Subject: Master Drainage Study for Sunrise Development and
Drainage Report for Sundown Subdivision Filing No. 3.

The purpose of this letter is to amend the Master Drainage Study for Sunrise Development and the Drainage Report for Sundown Subdivision Filing No. 3. The Master Drainage Study for Sunrise Development was signed by the City Engineer in May, 1984, and the final Drainage Report for Sundown Subdivision Filing No. 3 was signed by the City Engineer in July, 1984. Storm drain facilities will be continued in that portion of Rangewood Drive from Saddle Rock Road to Vickers Drive in order to eliminate the temporary outfall which was originally proposed in said Master Drainage Study.

SUNRISE DRAINAGE PLAN

MARCH 1984
REVISED JULY, 1984

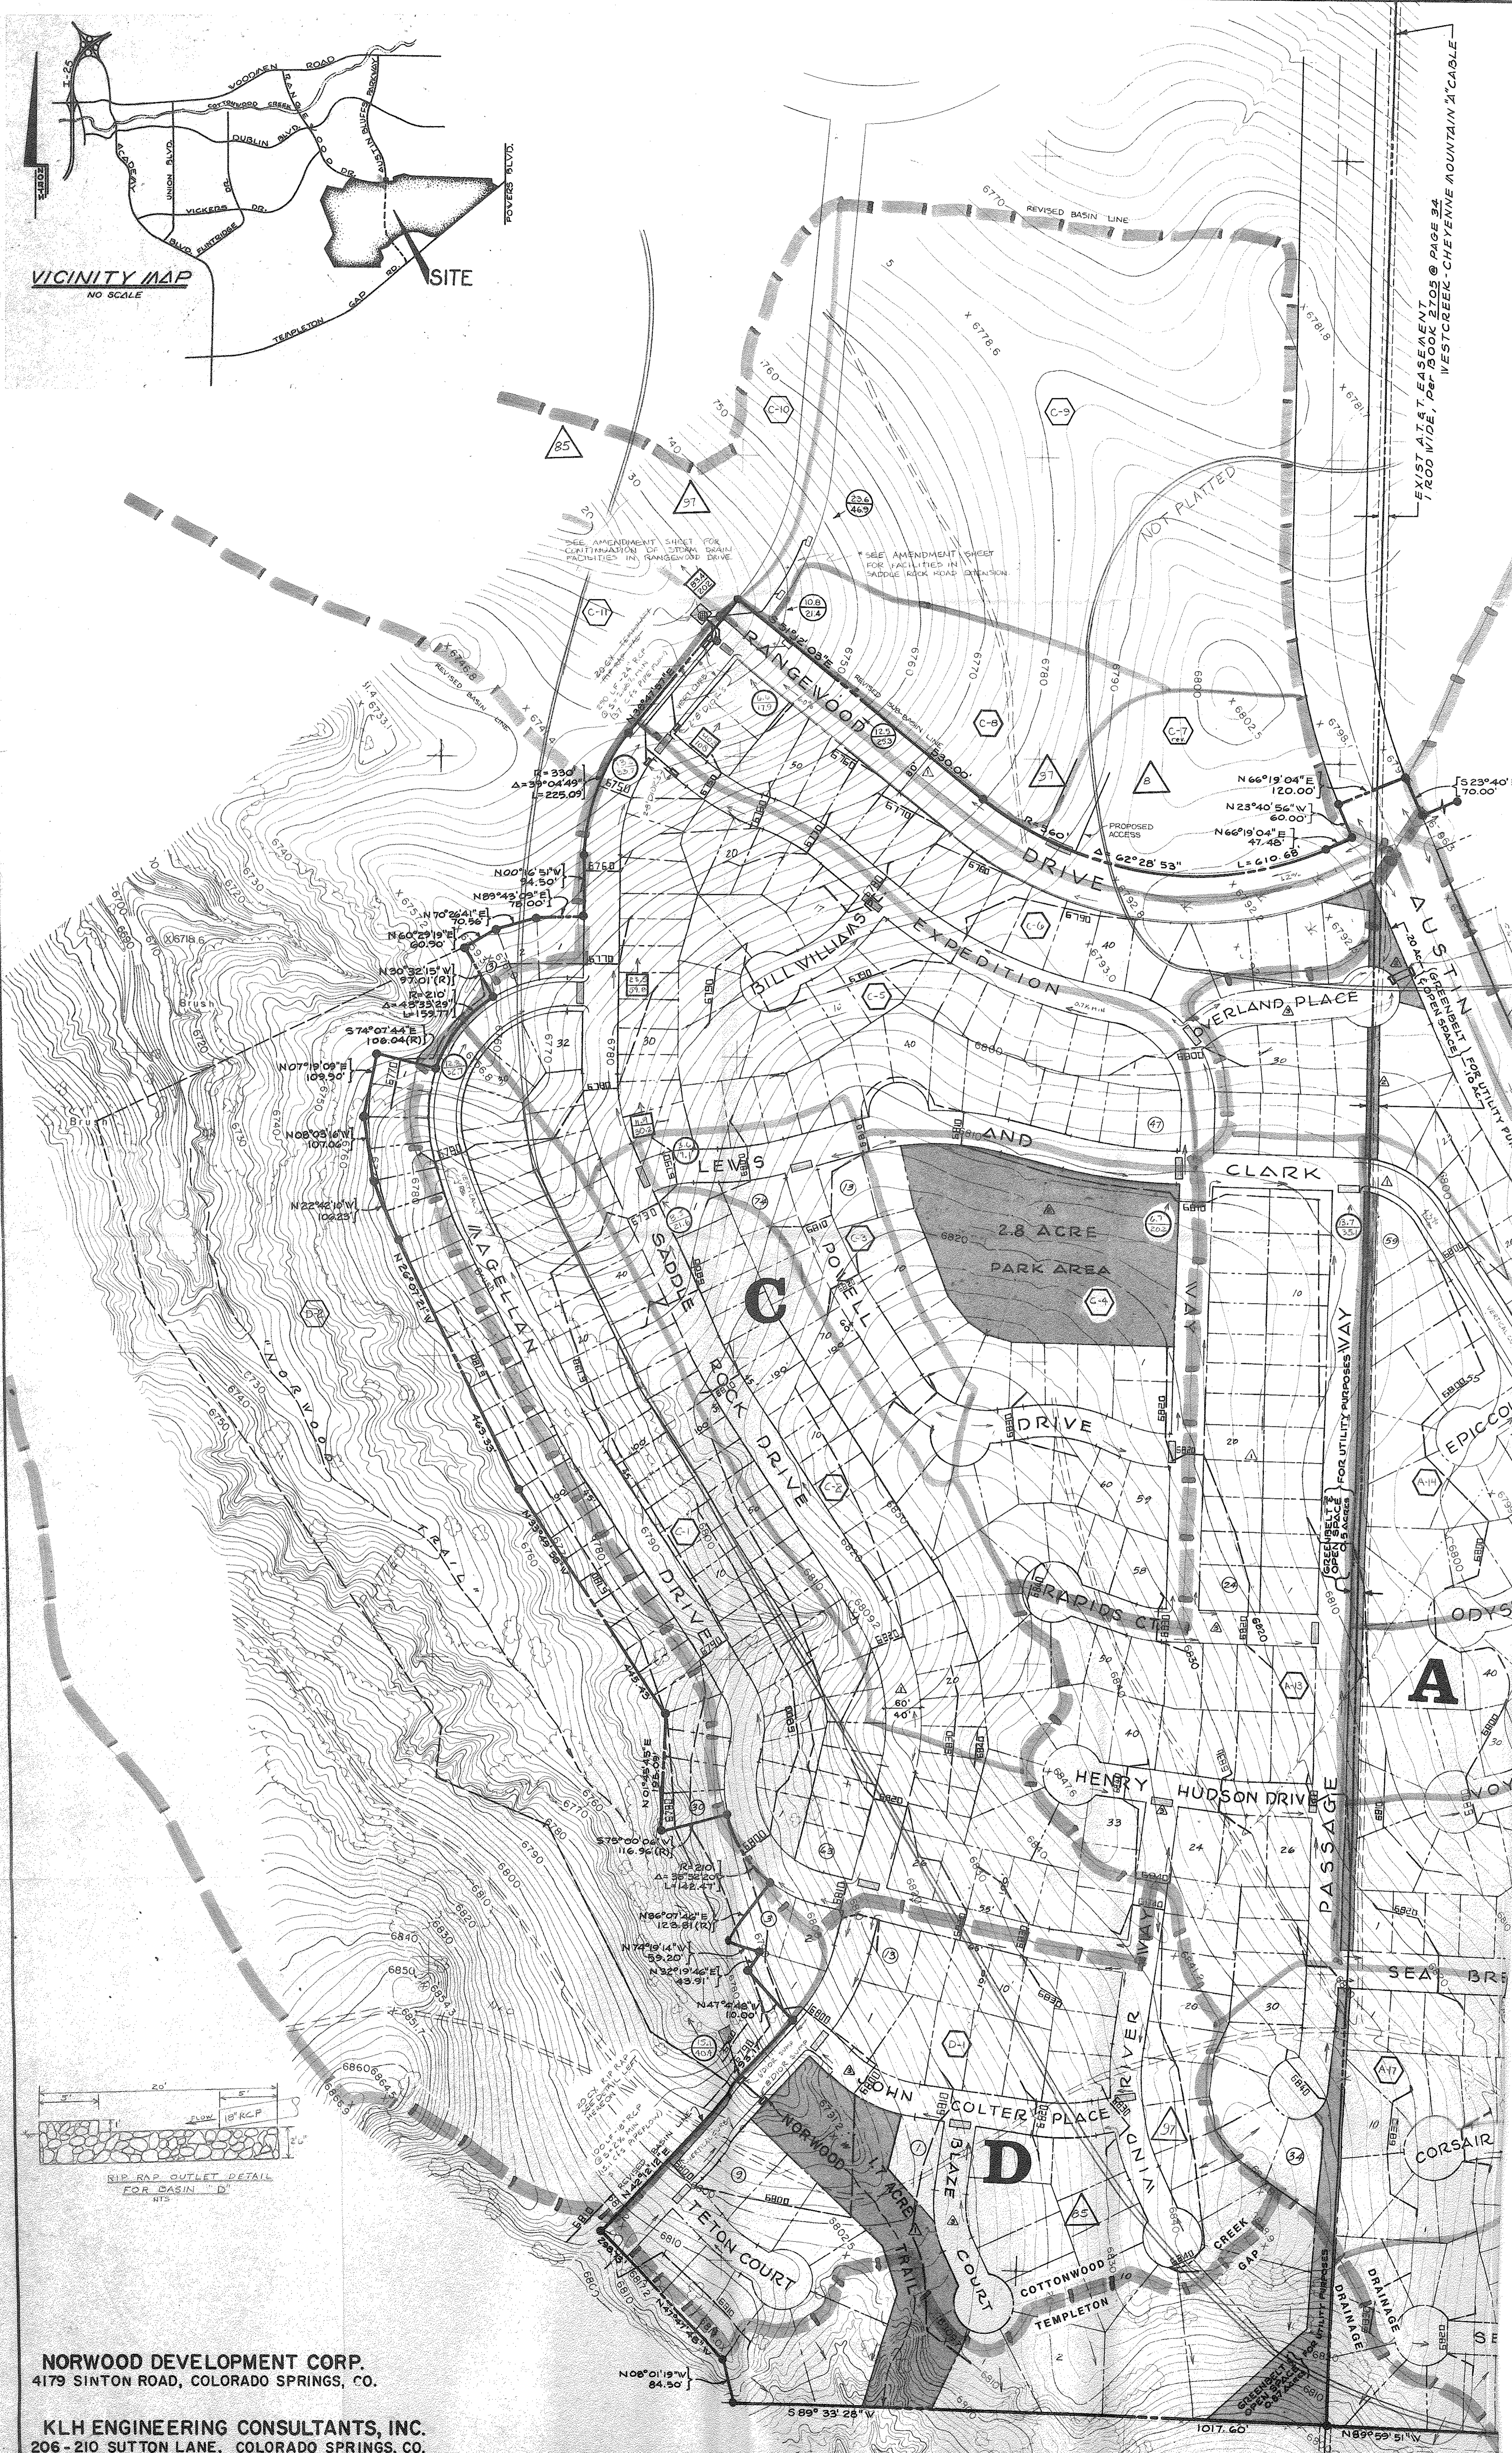
Basin C has been revised to include the additional sub-basins tributary to Rangewood Drive (see Amendment to Drainage Plans for Sunrise Development and Sundown Subdivision Filing No. 3). Runoff from these sub-basins will flow overland across lots, into the streets, and down the streets as gutter flow to catch basins in the proposed extension of Saddle Rock Road and in Rangewood Drive. This storm drain facility will tap into the existing 72-inch R.C.P. culvert which crosses under Rangewood Drive at the "Nor'wood Trail" drainage way. During the 5 year storm, approximately 5 c.f.s. will continue as gutter flow on the North side of Rangewood Drive to the intersection of Rangewood Drive and Vickers Drive, at which point it will be picked up by the existing sumped 12' D-10R (see Drainage Plan for Prominence Subdivision Filing No. 1). The complex horizontal layout of the storm drain system at the intersection of Rangewood Drive and Saddle Rock Road is required to provide clearance between the storm drain and the existing waterlines at this intersection.

Basin D has been revised to include all of the area which contributes runoff to the inlet of the existing 72-inch R.C.P. culvert. This 72-inch R.C.P. culvert was sized so that the HW/D value for the 5 year flow does not exceed 1.0, and so that flow from Basin D will not enter Rangewood Drive during the 100 year storm. For the 5 year design flow of 124 c.f.s., the HW/D value for the 72-inch R.C.P. is 0.74, and for the 100 year design

flow of 274 c.f.s., the HW/D value is 1.2. Since the flow line elevation of the 72-inch R.C.P. is approximately 18 feet below Rangewood Drive at the inlet, runoff from Basin D will not flow into Rangewood Drive during the 100 year storm.
